Sä Dena Hes Mine 2009 Dam Safety Review

Submitted to:
Teck Metals Ltd.
Sä Dena Hes Mine
c/o Bag 2000
Kimberley, BC V1A 2E1

Project Number: 09-1427-0023

Figure10
 Camp Creek Diversion (SRK 2009)

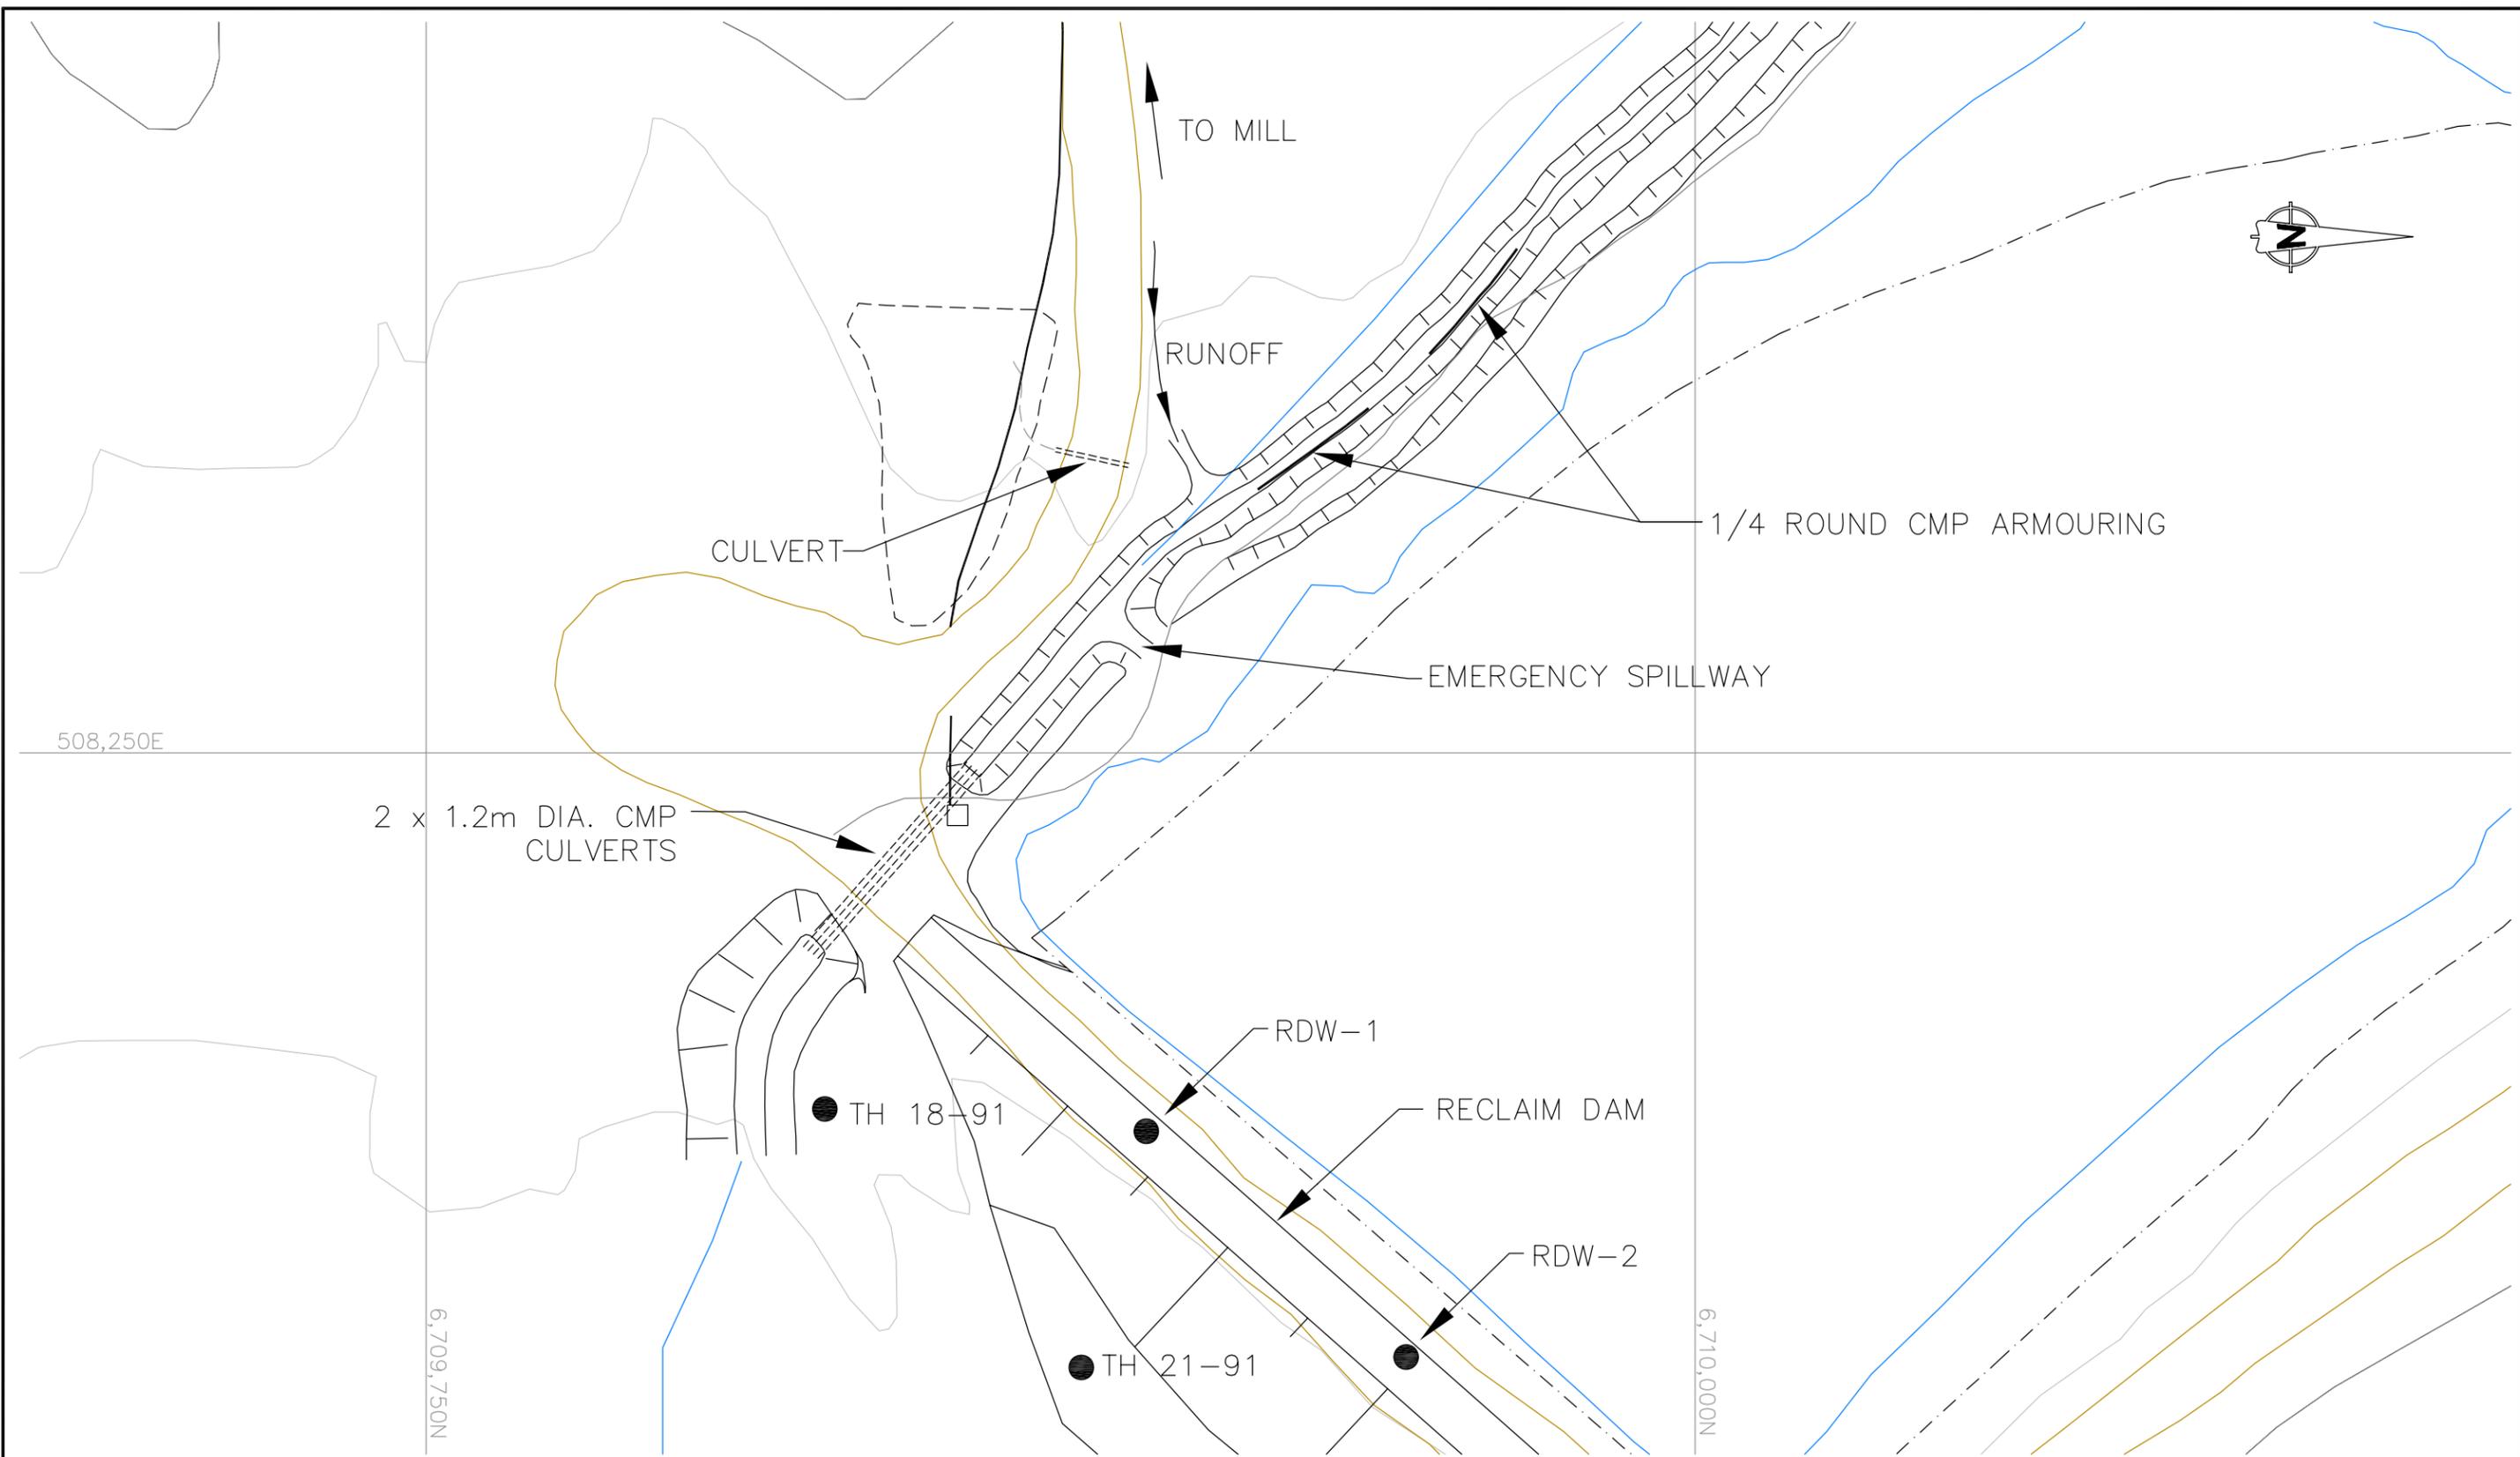
Lining for erosion protection was installed at the Reclaim Dam spillway and two sections within the diversion channel (1/4 round CMP armoring, Figure 10). The channel of Camp Creek Diversion is otherwise unlined.

sections of the diversion channel were unlined. Some signs of erosion were noted in unlined portions of the channel (e.g., gradient change in the channel side slope to the right of Photo 24). No major failure of the channel side slopes was however observed along the section of channel inspected.

- The conditions of the steel plate armour in the Camp Creek Diversion should be monitored on a regular basis and repairs undertaken as soon as possible, if needed. Alternate and more stable armouring options must be considered in plans for permanent closure of the mine site.
